Assessment of Dam Safety Coal Combustion Surface Impoundments Draft Report

American Electric Power
General James Gavin
Power Plant
Cheshire, Ohio

July 2, 2009

FIGURE 9B

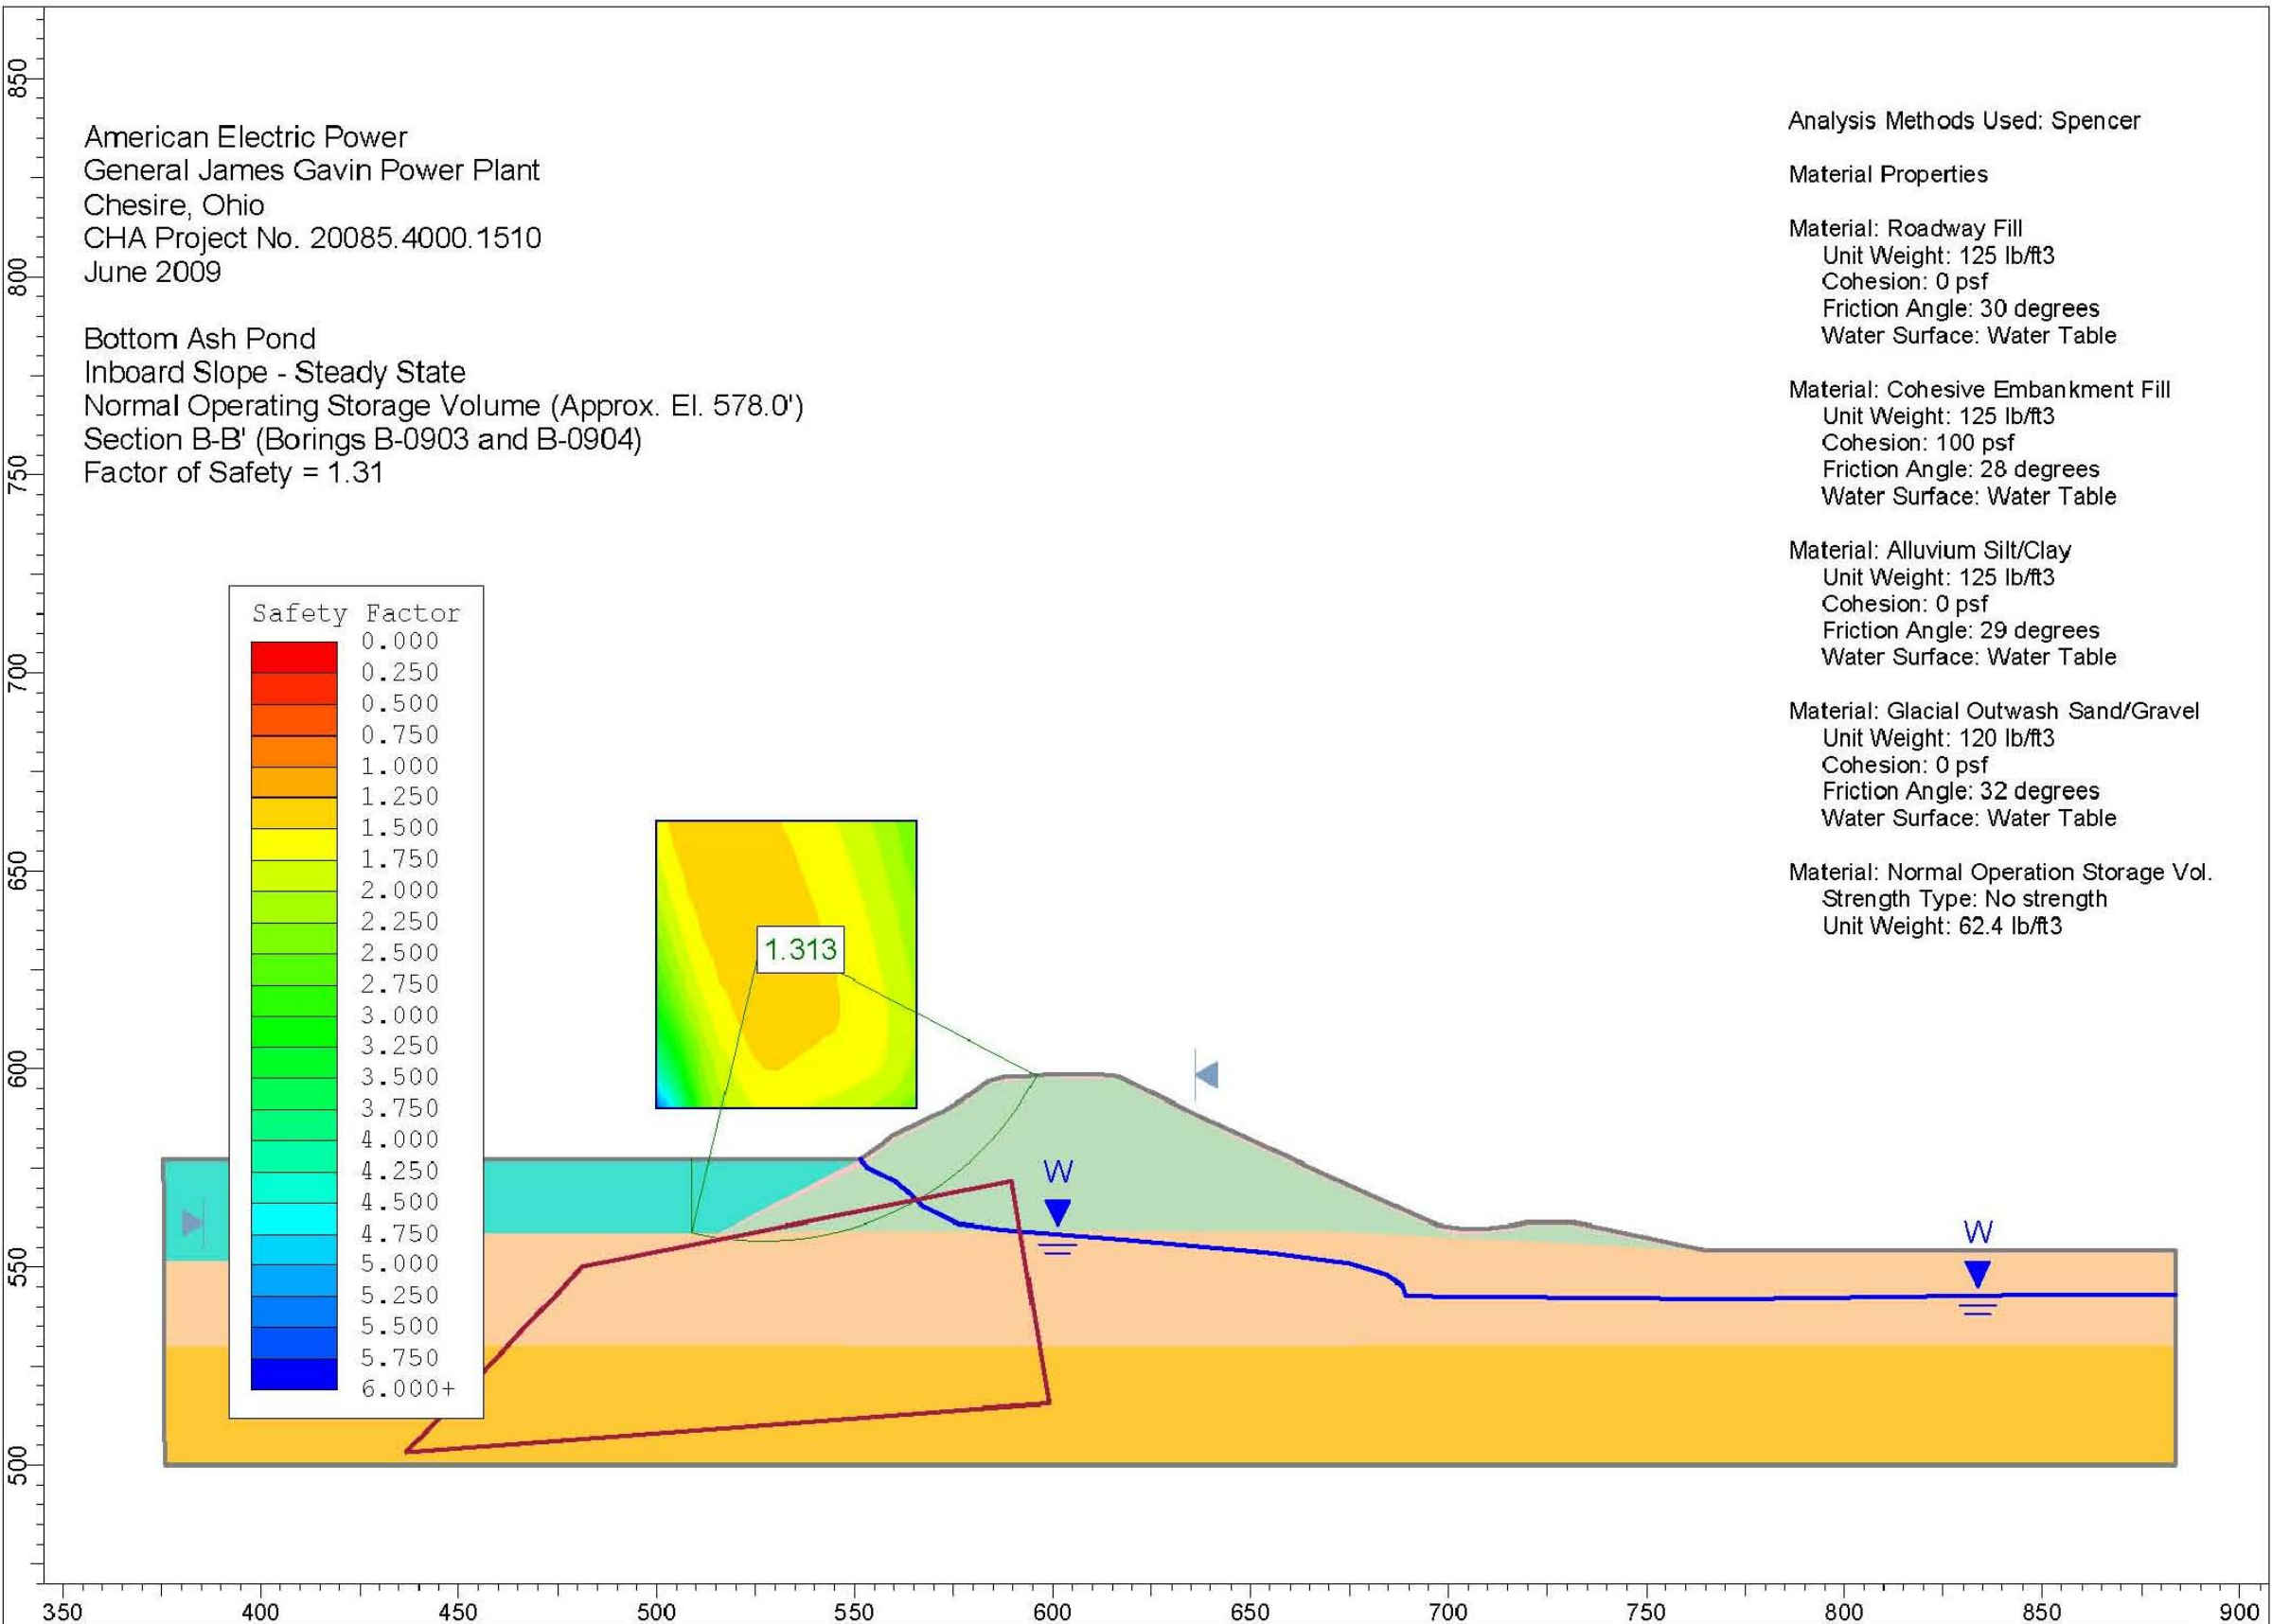
- The factor of safety for the upstream (inboard) embankment slope of the pond was not evaluated as part of BBCM's June 2009 investigation. CHA modeled the upstream slope using the south embankment geometry and the steady state loading condition (see Figure 9B) and the soil parameter provided in BBCM's report. The calculated factor of safety was 1.3 which is below the minimum required factor of safety (according to the USACOE).

CHA recommends the upstream slope be re-graded to correct the steepness and slumped areas for stabilization. This effort should be coordinated with the recommendations made in Section 4.11 to analyze the upstream slope.

FIGURE 9C

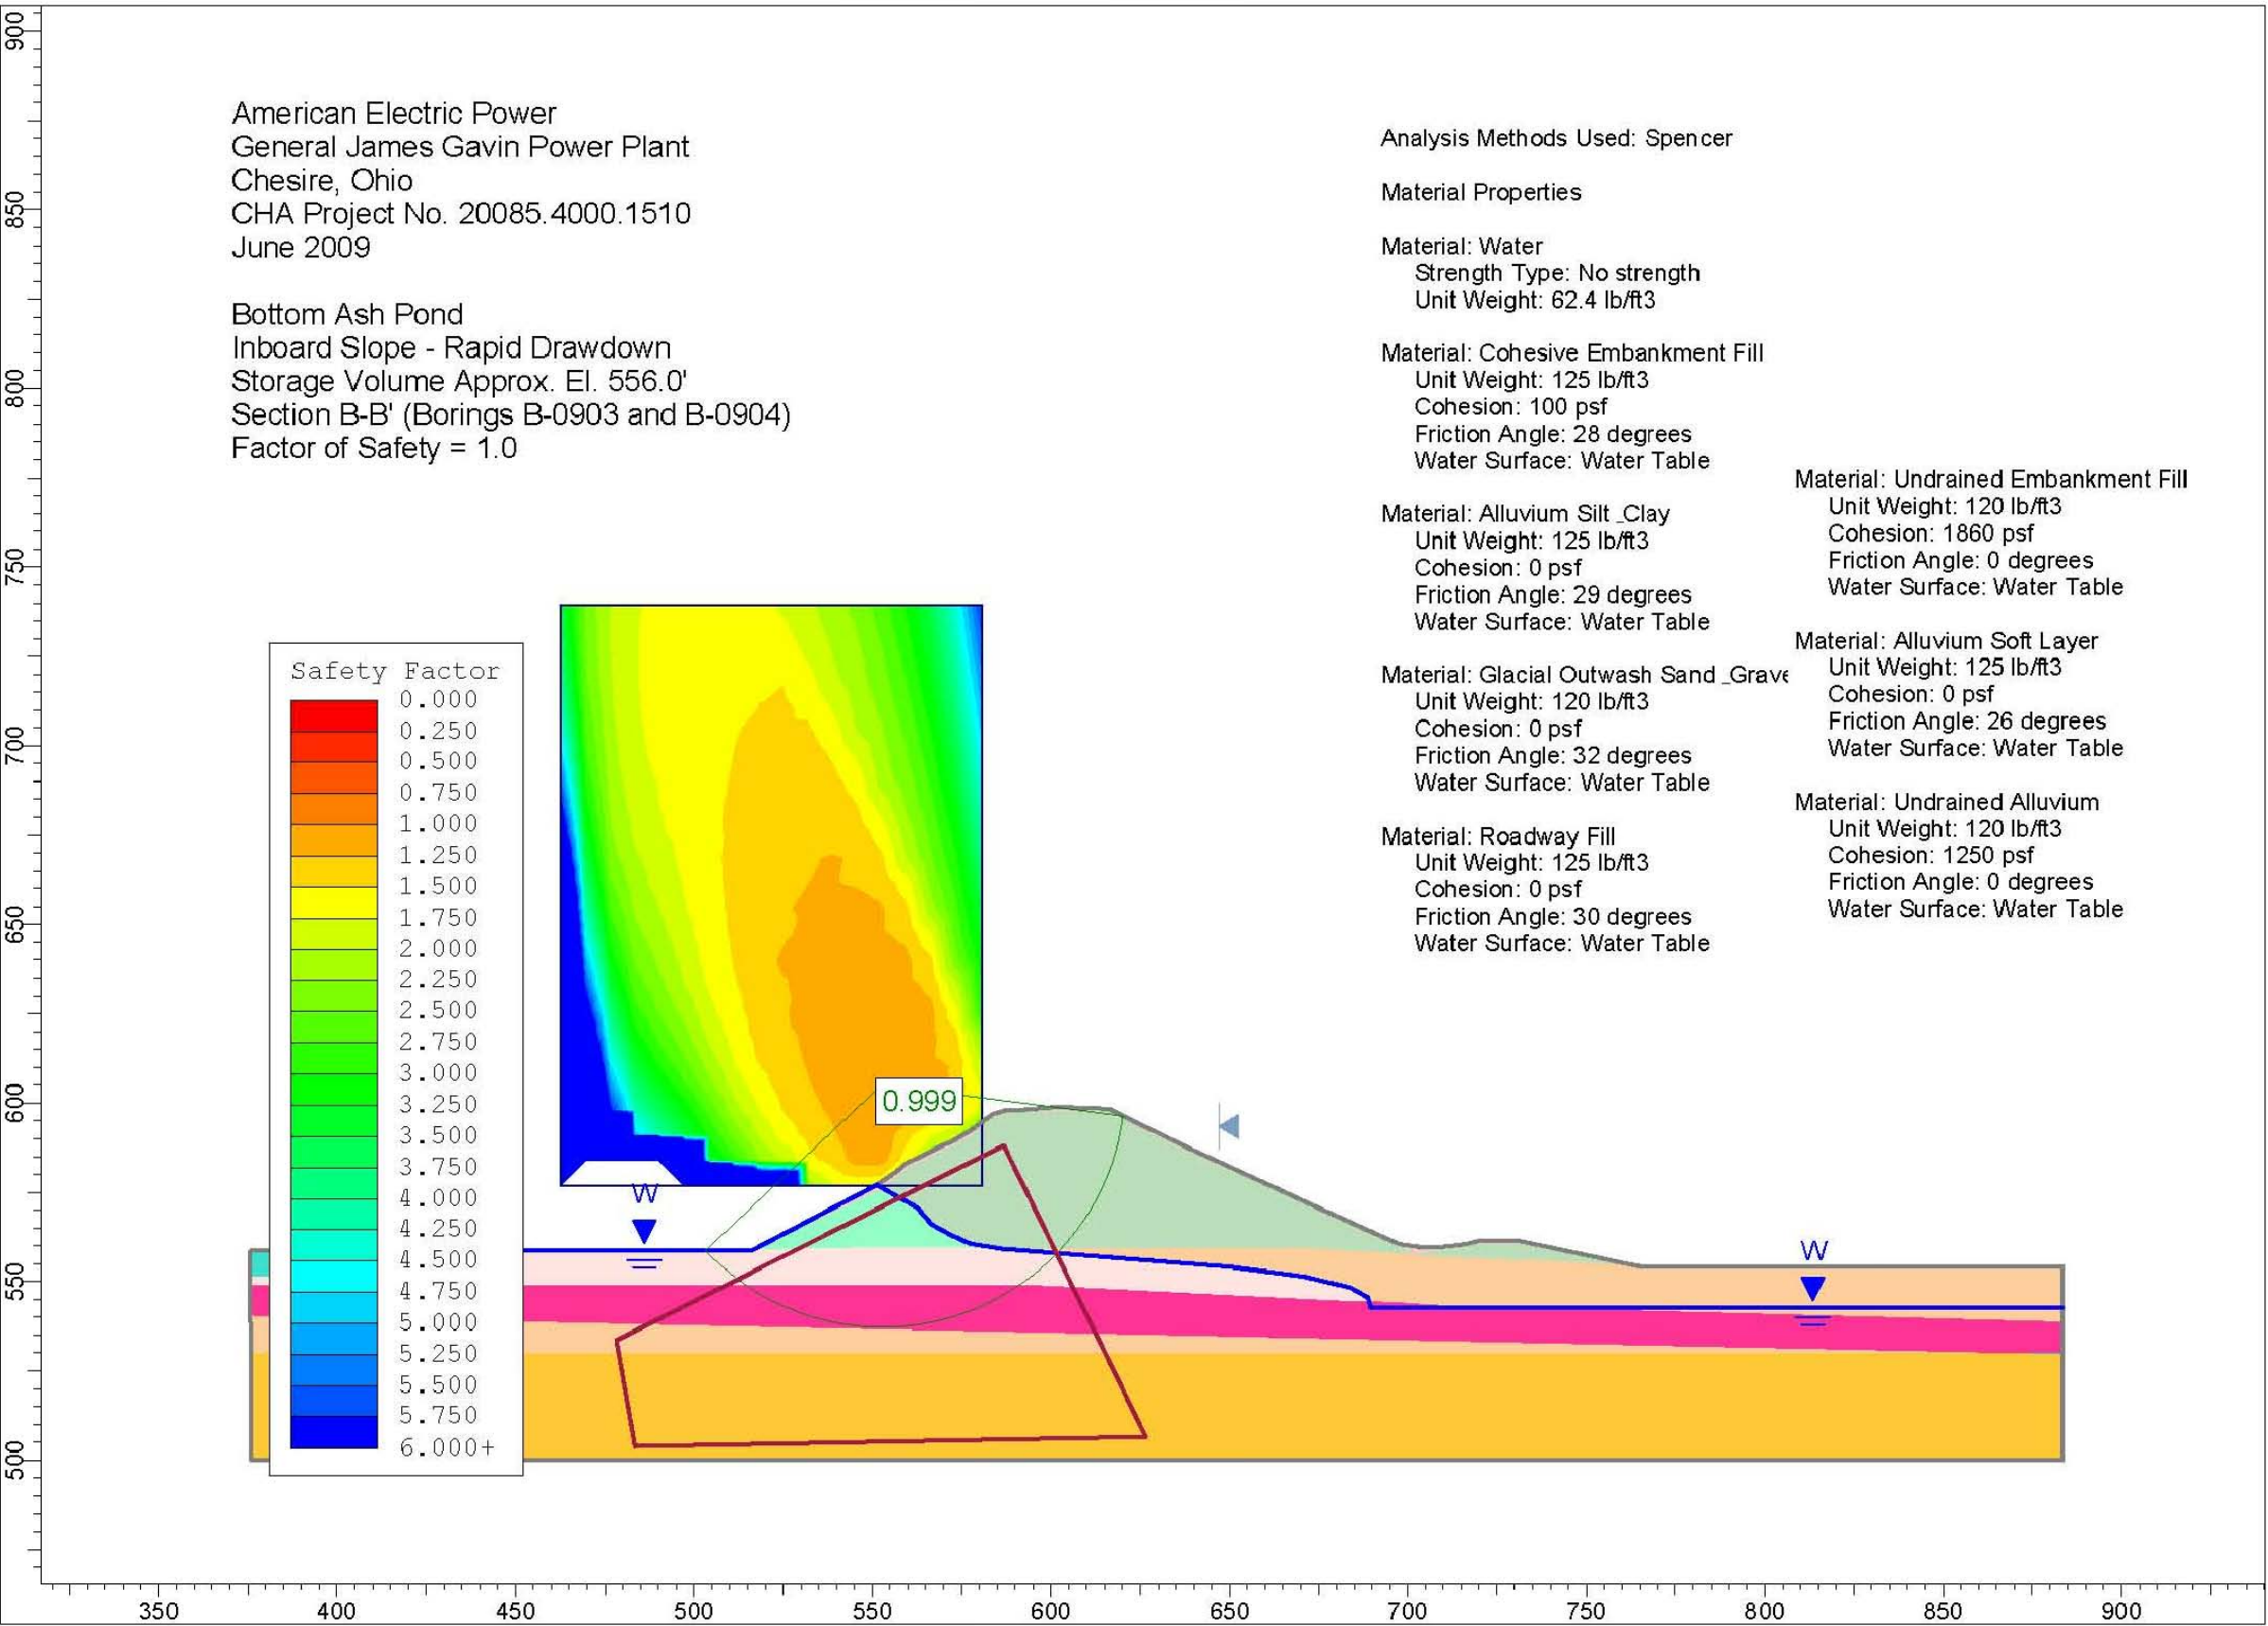
- The rapid-draw down load case was not evaluated as part of the June 2009 investigation. CHA modeled the south embankment slope using a combination of soil parameters provided in the June 2009 investigation report and parameters which may more closely represent field conditions (i.e. undrained embankment and alluvium soils on the upstream slope and a softer alluvium silt/clay layer). Figure 9C indicates that the calculated factor of safety for the rapid draw-down load condition is close to 1.0, which is below the minimum required value of 1.3 (according to the USACOE).
